**JOINT REGIONAL PLANNING PANEL
(Sydney East Region)**

JRPP No	2014SYE007
DA Number	DA.446/13
Local Government Area	North Sydney
Proposed Development	Construction of a 29 storey building containing 218 serviced apartments.
Street Address	80 Arthur Street North Sydney
Applicant	Karimbla Constructions Services (NSW) Pty Ltd
Number of Submissions	Six (6)
Report by	Geoff Mossemenear, Executive Planner, North Sydney Council

Assessment Report and Recommendation

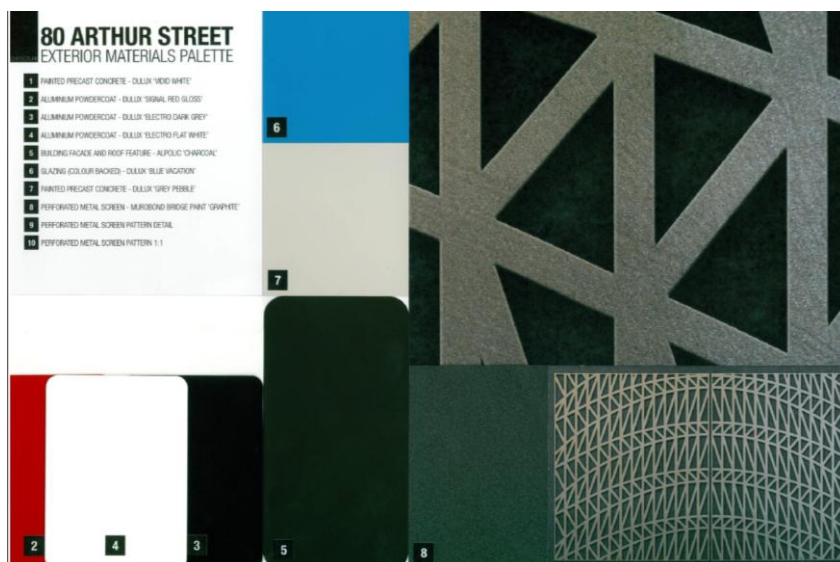
The subject site is within the Central Business District which falls within the North Sydney Centre Planning Area. The proposal is generally consistent with the character statement other than a podium setback at the Little Walker Street elevation. The podium height to Little Walker Street and the treatment of the three other elevations are considered satisfactory.

The applicant was requested to provide further details on how the setback requirement

Further amendments were sought to improve the rear facade and setback. Amended plans were submitted on 19 March 2014 with the following comments:

Amended plans were submitted on 3 March 2014 with the following submission:

The proposal results in a weighted setback of 1.8 metres. However, the building footprint has been designed to relate to the adjoining development by incorporating a deep 6 metre rear setback alongside the northern side boundary and a full separation from the southern boundary (3 metre side setback). The remainder of the façade incorporates setback elements of varying amounts. This creates a well-articulated façade that responds to the adjoining development and provides an appropriate response to Little Walker Street.

Having regard to the amendments and the above submissions, the podium setback is considered to be acceptable and is supported. The average setback would appear to be greater than the setback for the commercial building approved by Council in 2010.
